**PLANNING COMMISSION  
REGULAR MEETING**

Site Plan Review for New Building 185 7th Street NE & Parking Variance

RE: Site Plan Application  
Excel Mechanical  
Engineering Review #1

RE: Site Plan Application  
Waconia Roll-off  
Engineering Review #1

Exhibit C - Grading Plan dated October 16, 2019

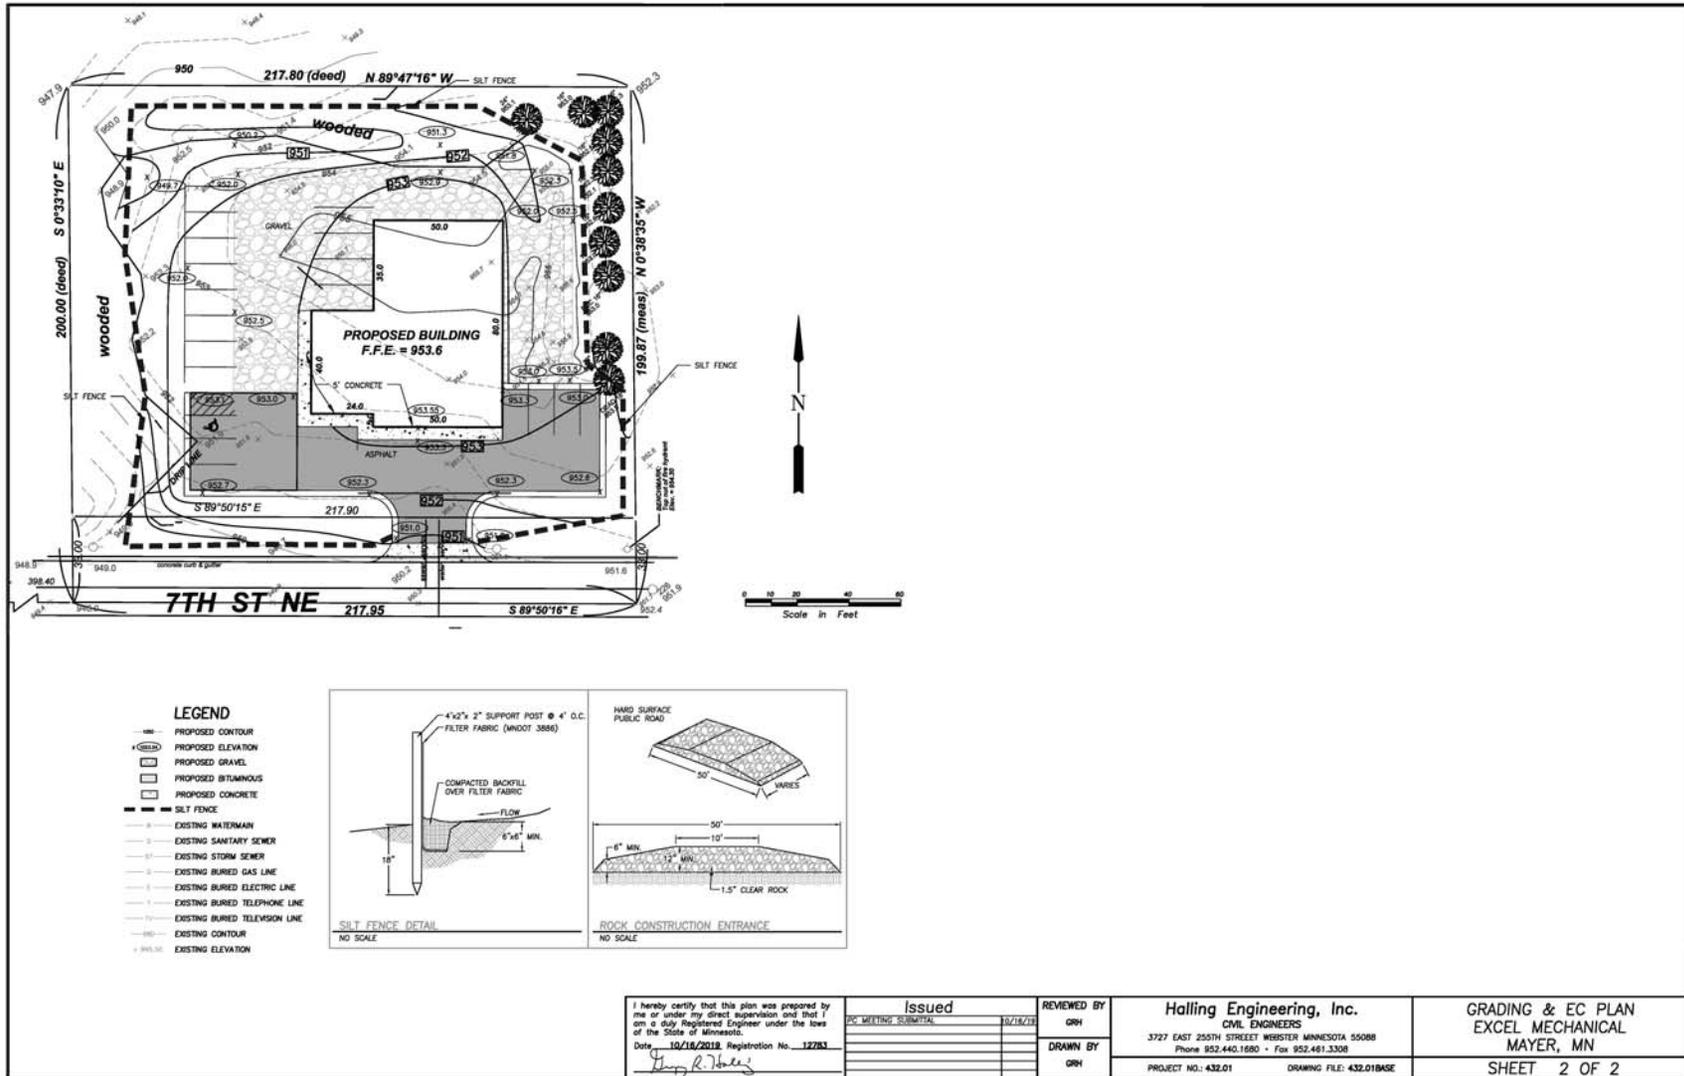
11. Slopes should be included on the Grading Plan as necessary to define slopes. A minimum slope of 2% and maximum of 10% are recommended for parking lots.

12. Additional detail should be provided for the proposed grading on the east side of the building. Spot elevations and contours should be included as necessary to adequately define proposed grades in this area.

Exhibit E - Building Plans Page 1

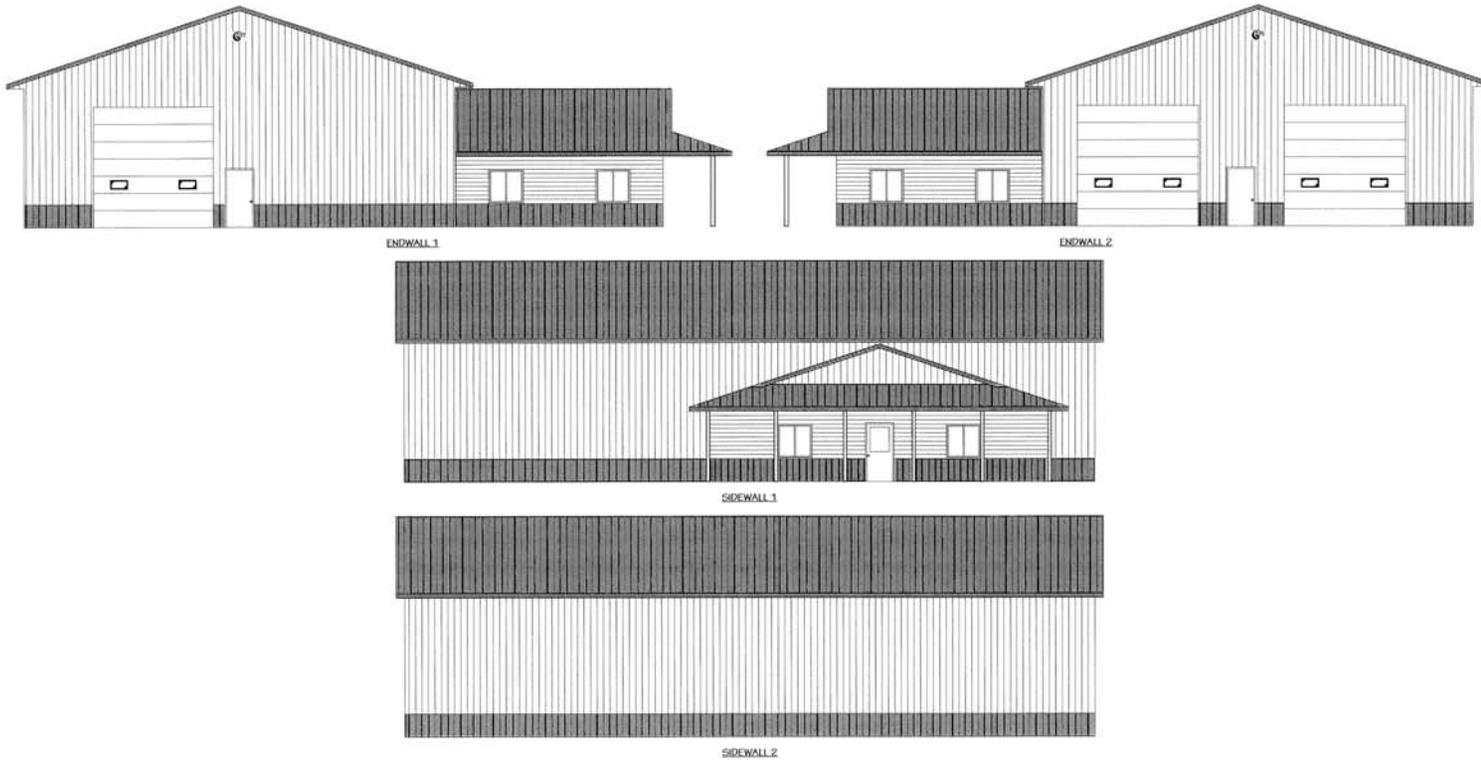
The proposed building is to be a sided and roofed with steel siding and roofing material and a light gray in color. The roof and bottom band will be a darker gray in color. the front of the building facing 7th Street NE will have two larger over head garage doors with one service door in between them. The office portion of the building will be located on the west side of the building with the main access point to the building located on the west side of the building. It should be noted that the building plans show a six foot overhang to the posts on the front entrance but the sidewalk proposed here is only five feet. A condition should be to widen the sidewalk to the edge of the posts for the overhang.

Exhibit C - Construction Plans dated October 25, 2019 page 6

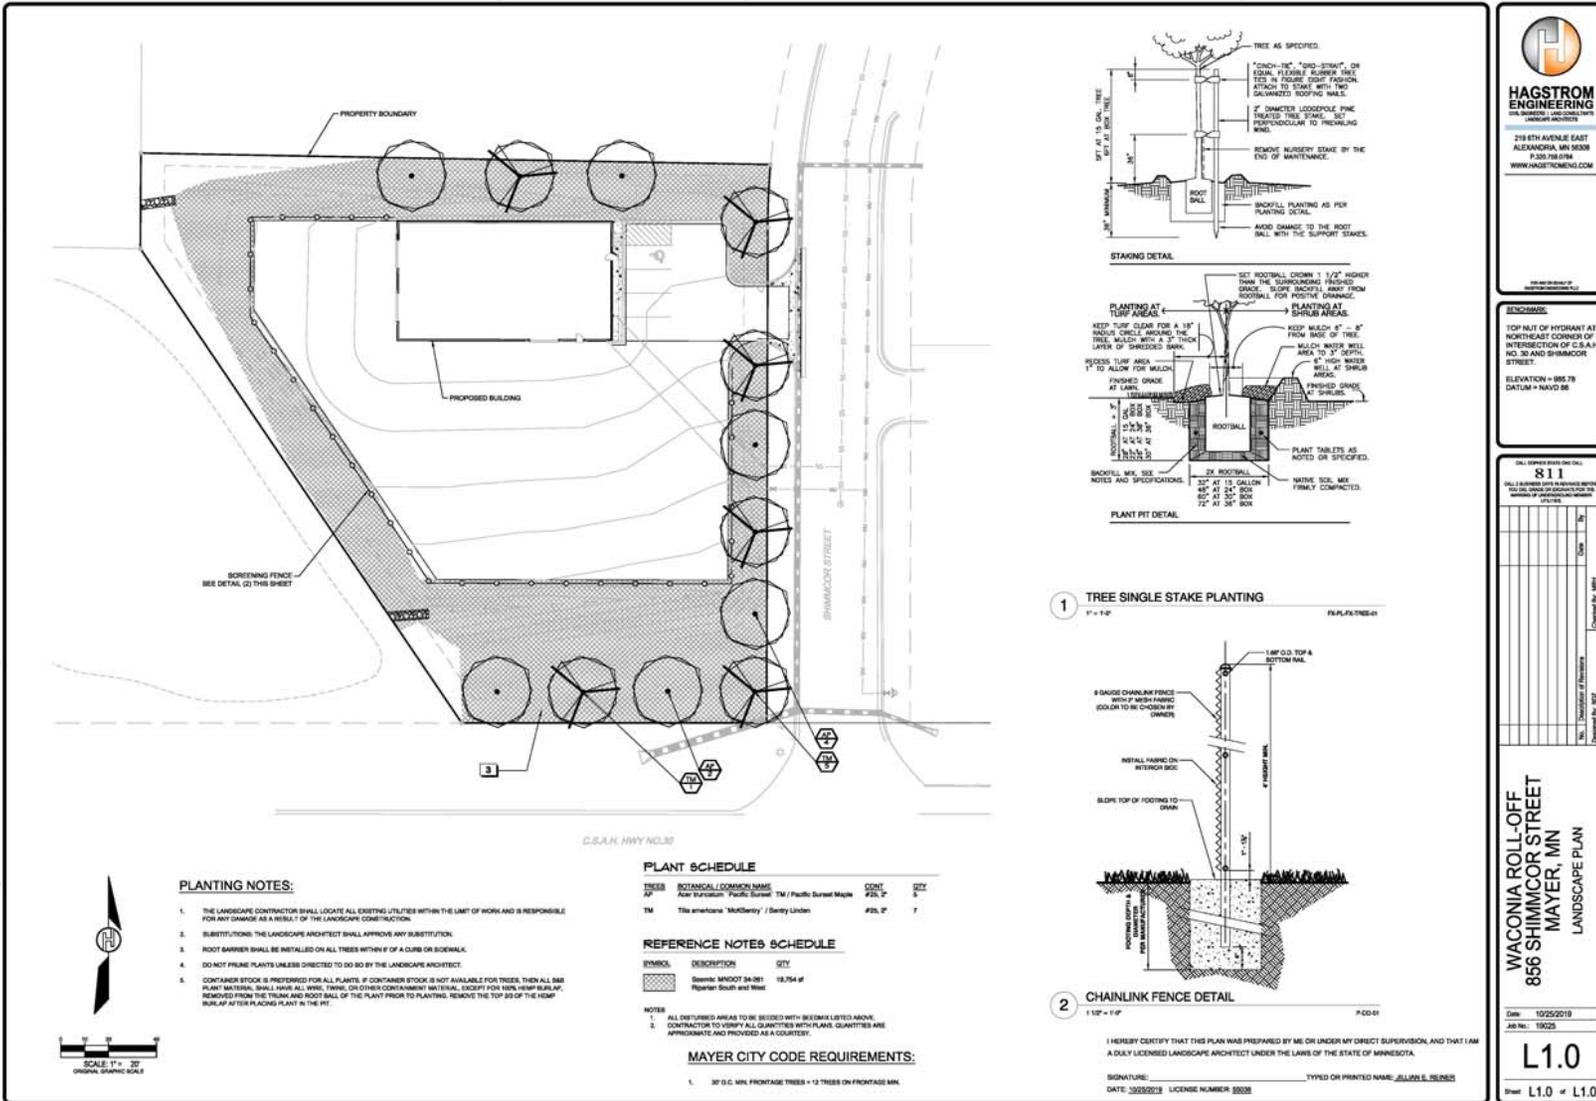
This means any outdoor storage on this property will have to be screened within the confines of a 100% opaque wall, fence, berm, plantings or combination of those items. The applicant has proposed a four foot minimum high chain link fence around the gravel area. This fence would have two inch mesh fabric installed on the interior side for screening purposes. The fence would extend west from the northwest corner of the building then turn south and then southeast, eventually running east along the CSAH 30 right of way and finally turning north and ending at the paved drive lane entrance off of Shimmcor Street. This fence will need to be six feet high and 100% opaque to meet the screening requirements.

One item that needs to be addressed is if a trash enclosure will be needed or is proposed. The site plan does not show a trash enclosure on the property, but if the applicant is going to have a dumpster on site it will need to be screened from the public right of way. It will have to be discussed if a trash enclosure will be located on the property and how it will be accessed. If one is to be proposed on the gravel area somewhere, it would be screened, along with the rest of the outdoor storage by the proposed fence.
